Project	IEEE 802.16 Broadband Wireless Access Working Group < http://ieee802.org/16 >	
Title	Remedy for relaying compressed DL-MAP/UL-MAP, HARQ-MAP and SUB-DL-UL-MAP	
Date Submitted	2007-07-18	
Source(s)	Kanchei (Ken) Loa, Yi-Hsueh Tsai, Hua-Chiang Yin, Shiann Tsong Sheu, Yung-Ting Lee, Youn-Tai Lee Institute for Information Industry 8F, No. 218, Sec. 2, Dunhua S. Rd., Taipei City 106, Taiwan Hongyun Qu, Mary Chion ZTE Corporation	Voice: +886-2-27399616 Fax: +886-2-23782328 loa@iii.org.tw qu.hongyun@zte.com.cn mchion@zteusa.com
Re:	IEEE 802.16j-07/019: "Call for Technical Comments Regarding IEEE Project 802.16j"	
Abstract	This contribution proposes the enhanced remedy of relaying compressed DL-MAP and UL-MAP, HARQ-MAP and SUB-DL-UL-MAP, which do not have MAC headers and management message types.	
Purpose	Text proposal for 802.16j Baseline Document.	
Notice	<i>This document does not represent the agreed views of the IEEE 802.16 Working Group or any of its subgroups. It represents only the views of the participants listed in the "Source(s)" field above. It is offered as a basis for discussion. It is not binding on the contributor(s), who reserve(s) the right to add, amend or withdraw

Figure xxx –Relaying DCD/UCD procedure

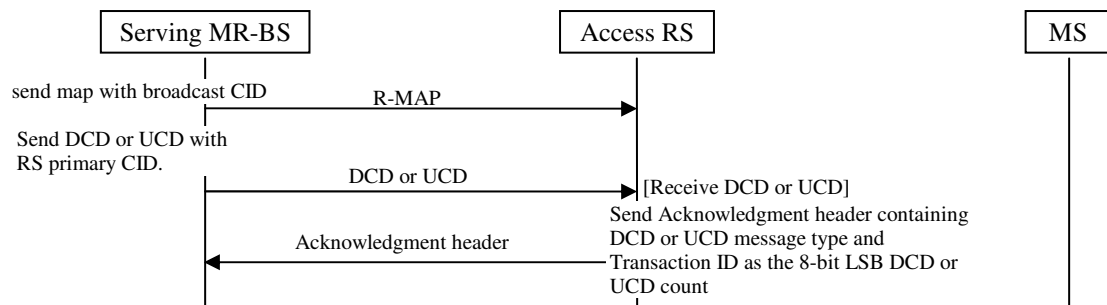
Upon receiving the DCD/UCD message with RS primary CID, as shown in Figure xxx, the RS shall acknowledge the reception of DCD or UCD messages over primary management connection by sending an acknowledgment header (See 6.3.2.1.2.2.2.3). The Transaction ID of the ACK header shall be set to the Configuration Change Count of DCD or UCD message. There shall be one ACK header per message. The RS may retransmit DCD/UCD message if the acknowledgement header is not received at the expiration of T52 timer.

Figure yyy – DCD/UCD broadcasting with centralized scheduling

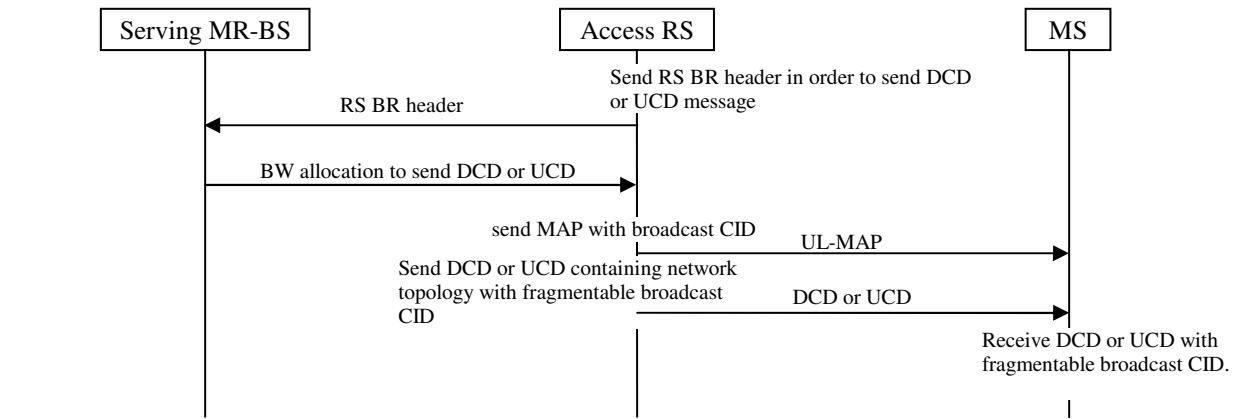
Under centralized scheduling, as shown in Figure yyy, the RS should request bandwidth on the access link to broadcast the DCD/UCD message with fragmentable broadcast CID.
